STATE OF TENNESSEE
DEPARTMENT OF TRANSPORTATION

**STATE OF TENNESSEE
DEPARTMENT OF TRANSPORTATION**

INDEX OF DRAWINGS
 STATE ROUTE 180 OVER OVERFLOW
 BRIDGE I.D NO. 38S80510007
 STATION 105+91.00
 LOG MILE 4.57
 HAYWOOD COUNTY
 2026

STATE OF TENNESSEE
 DEPARTMENT OF TRANSPORTATION
INDEX OF DRAWINGS
 S.R.180 OVER LOST CREEK
 BRIDGE I.D. NO. 38S80510009
 STATION 115+74.17
 LOG MILE 4.75
 HAYWOOD COUNTY
 2026

PRESENT
LAYOUT

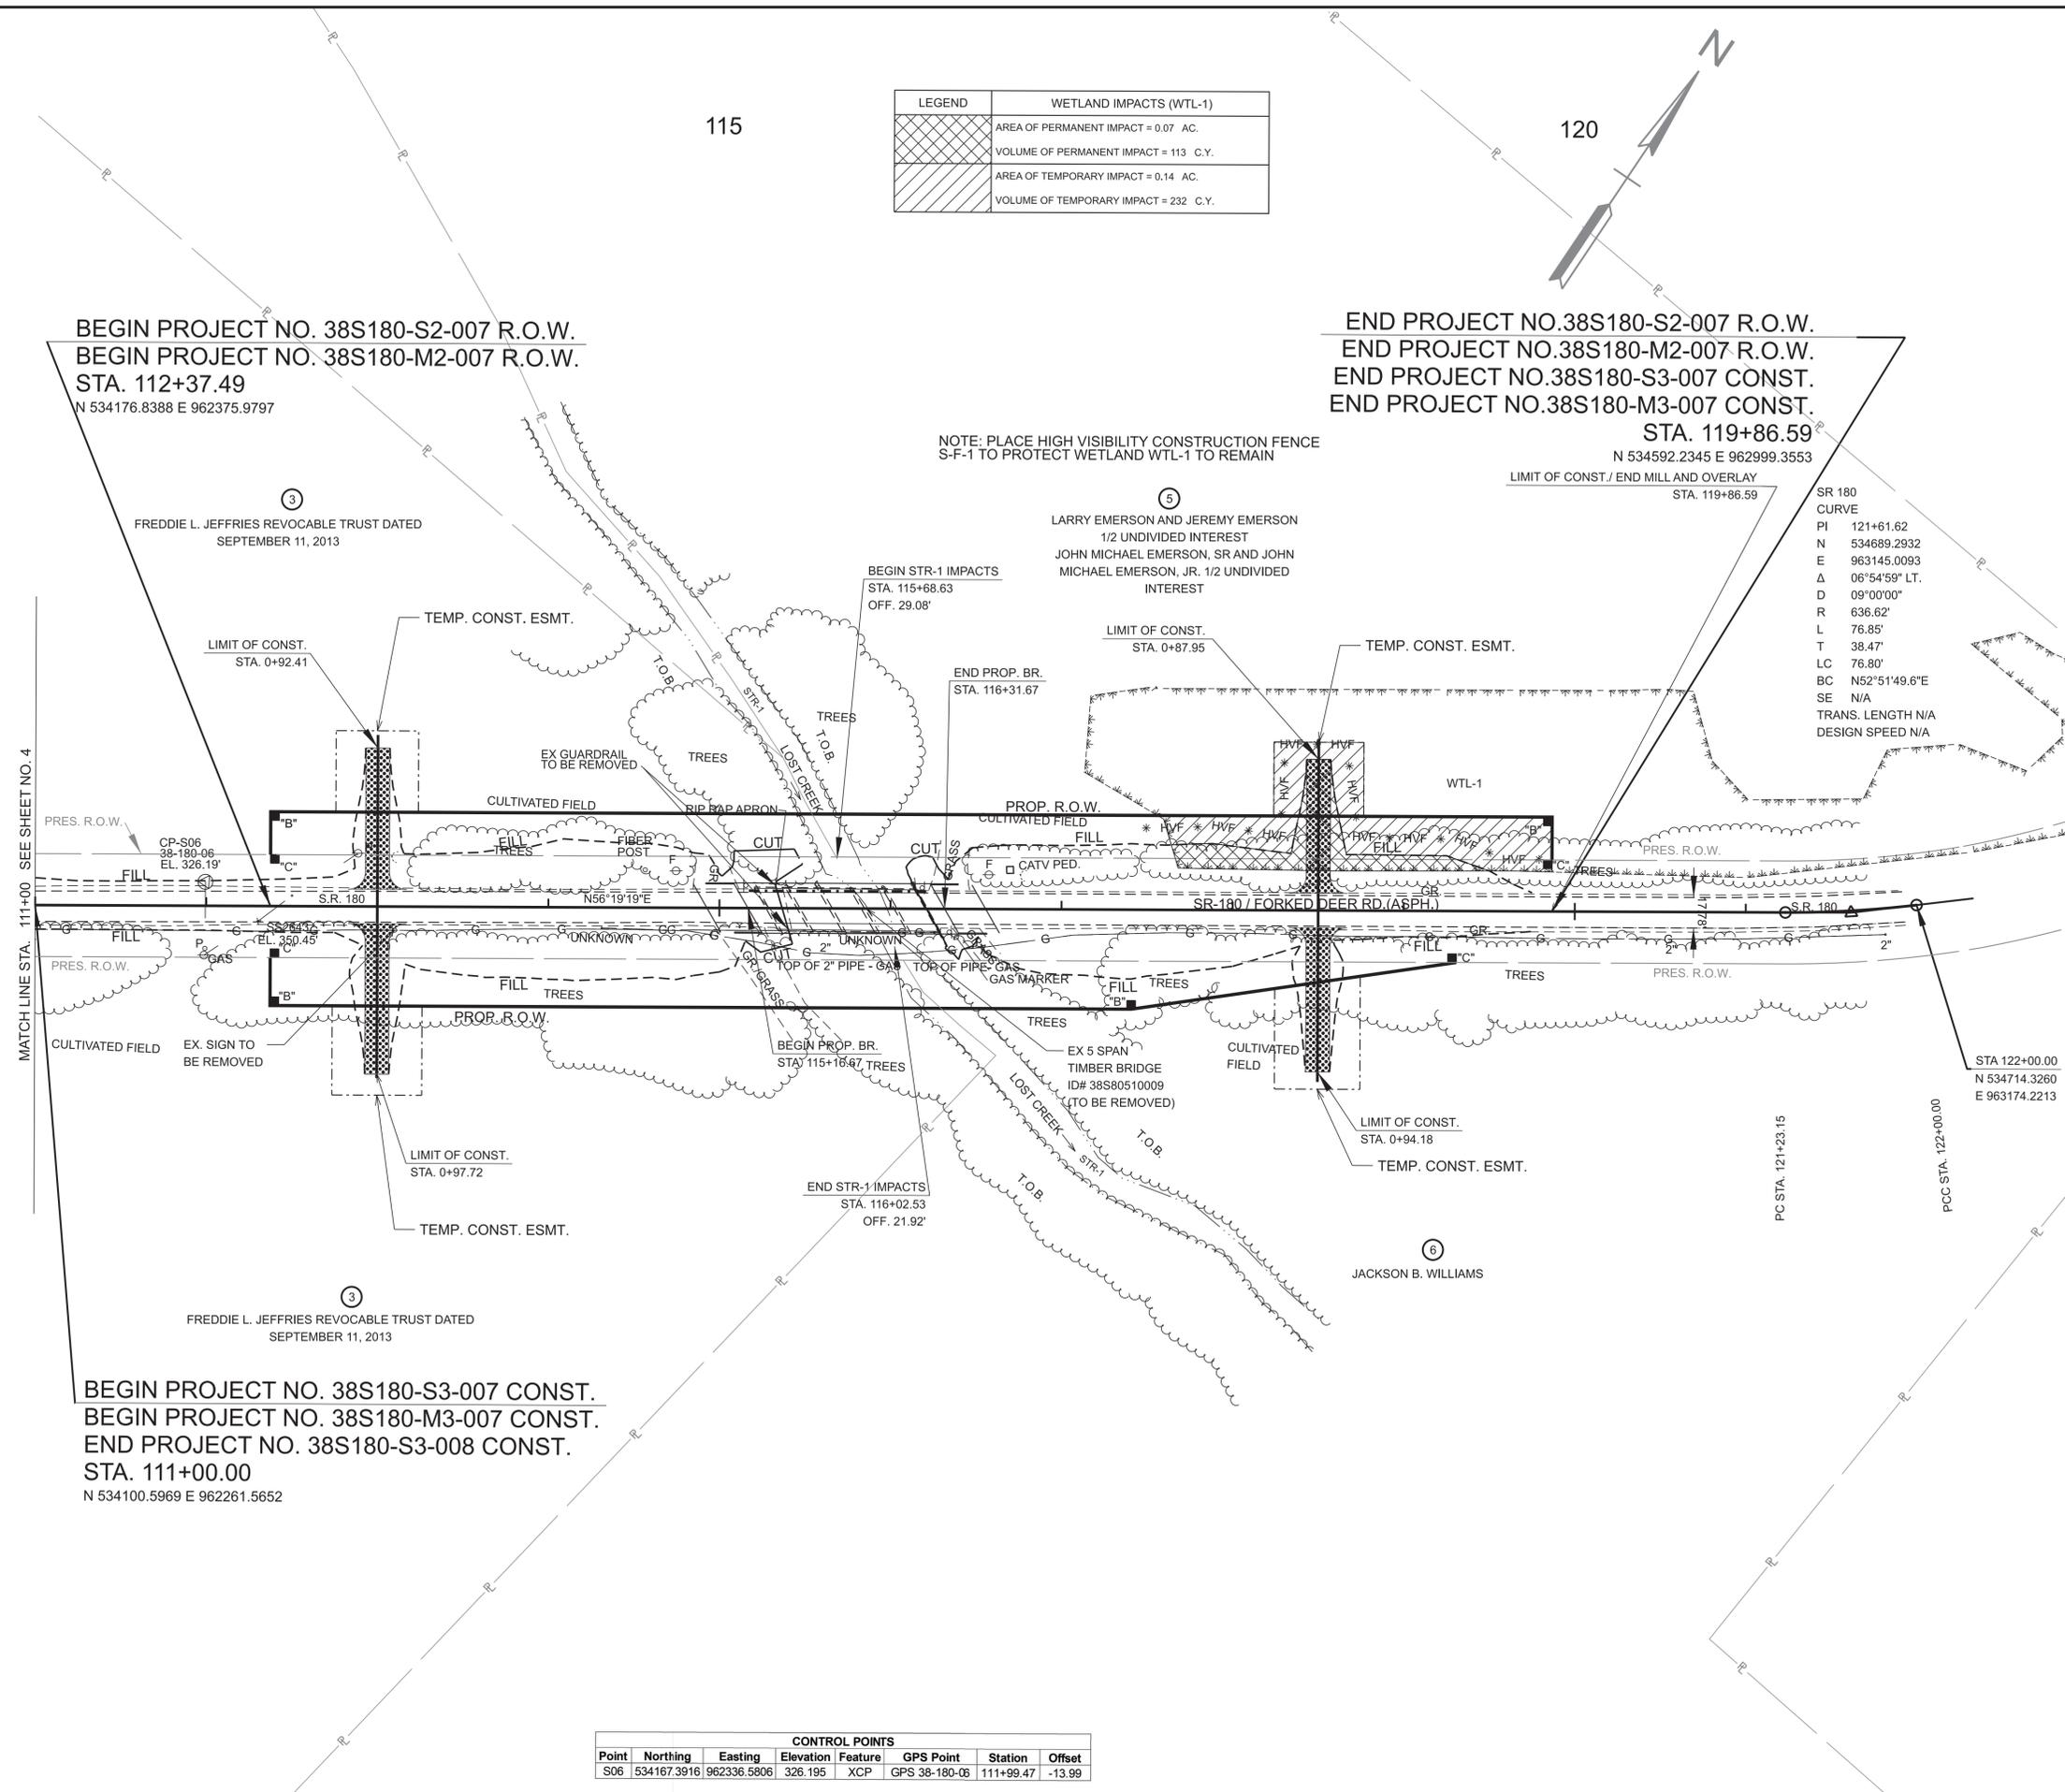
REV. 12-17-2025
REVISED TRACT 5 OWNER NAME.

**RIGHT OF WAY
DETAILS**

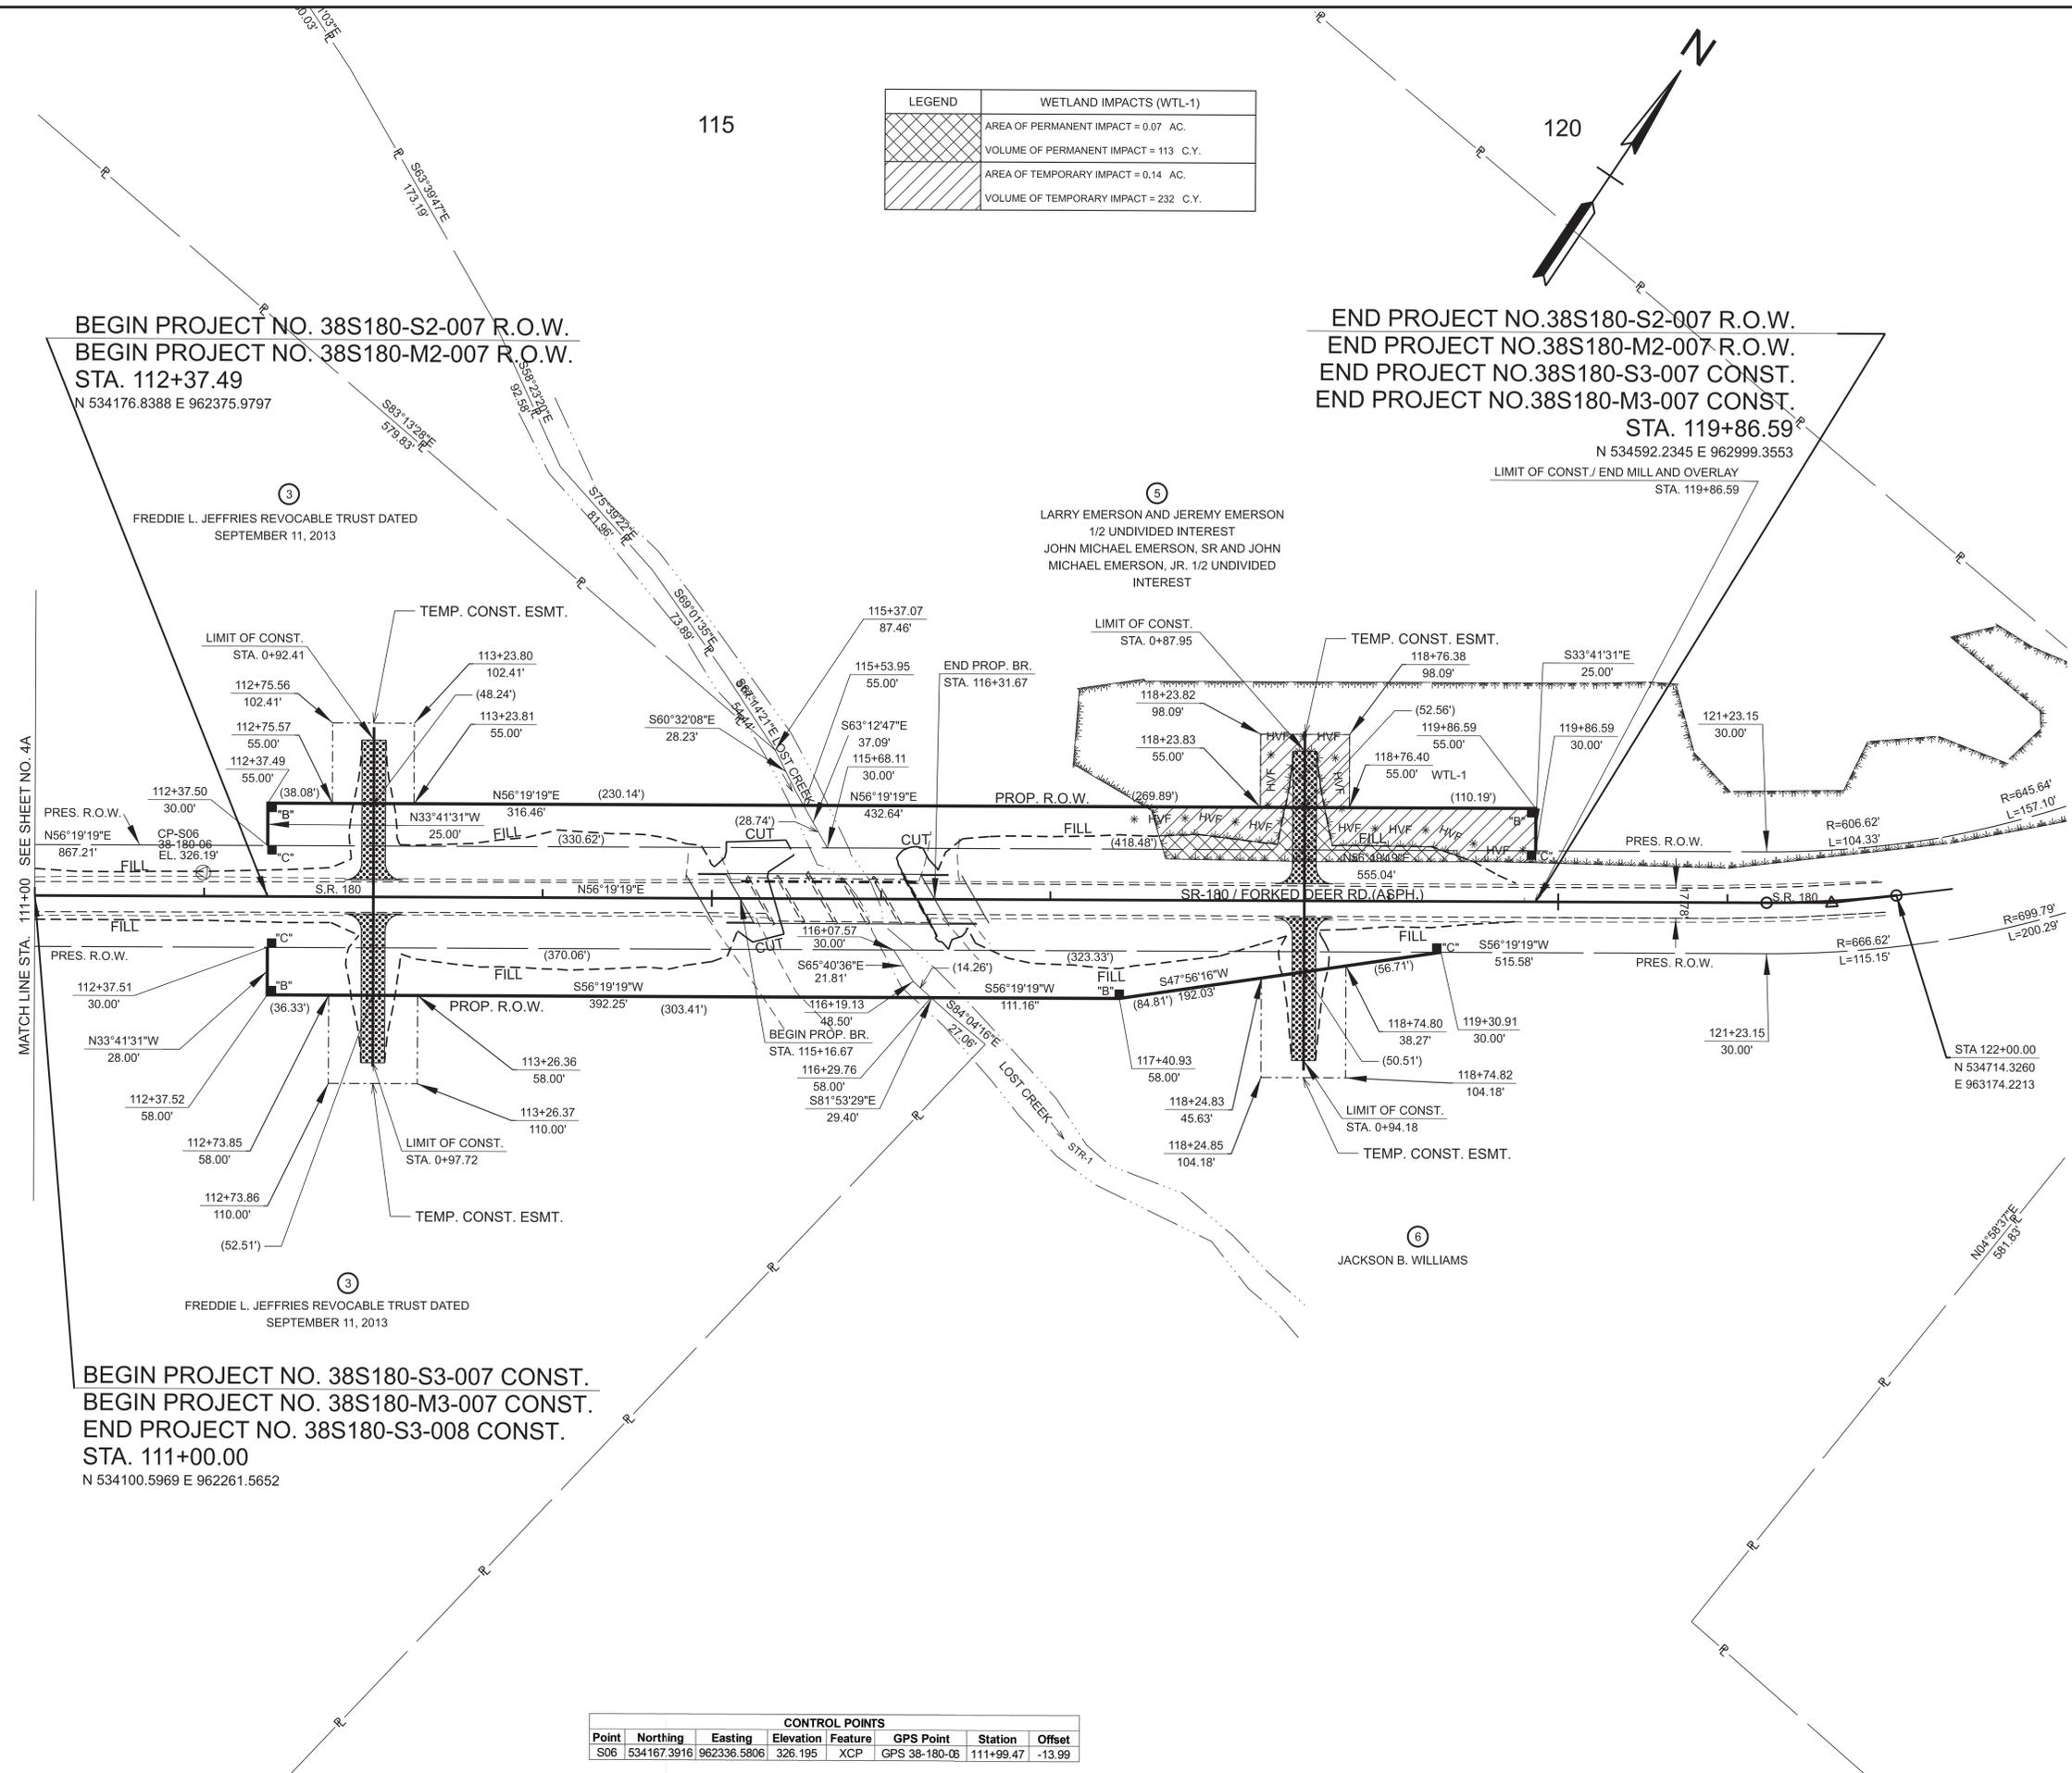
REV. 12-17-2025
REVISED TRACT 5 OWNER NAME.

STATE OF TENNESSEE
DEPARTMENT OF TRANSPORTATION
**GENERAL NOTES AND
ESTIMATED QUANTITIES**
STATE ROUTE 180 OVER FLOW
BRIDGE I.D NO. 38S80510007
STATION 105+91.00
LOG MILE 4.57
HAYWOOD COUNTY
2026

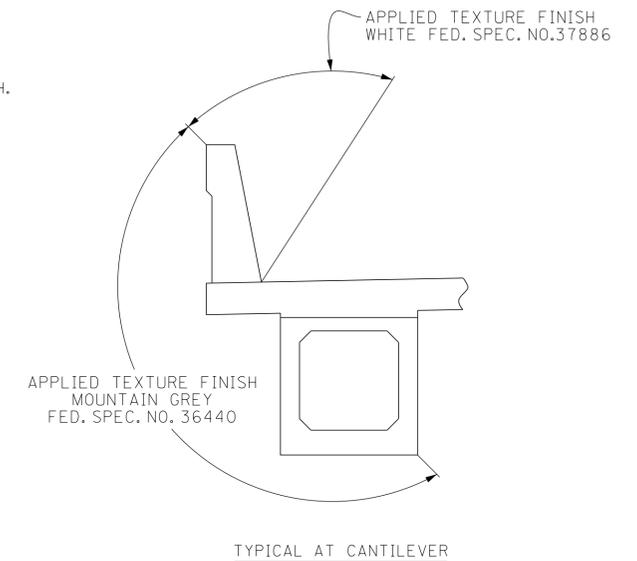
| 1 | 12/17/2025 | CDG | Revised quantity for Item No. 202-01.02, 606-18.01, & 606-18.03. Updated Item No. 202-04.01 to Item No. 202-04.02 |

ESTIMATED BRIDGE QUANTITIES

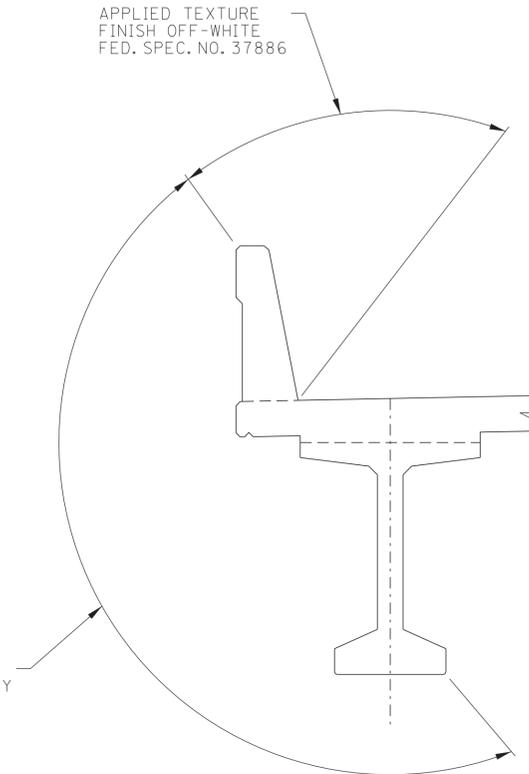
| 1 | 12-17-2025 | RMP | REVISED ESTIMATED QUANTITIES |
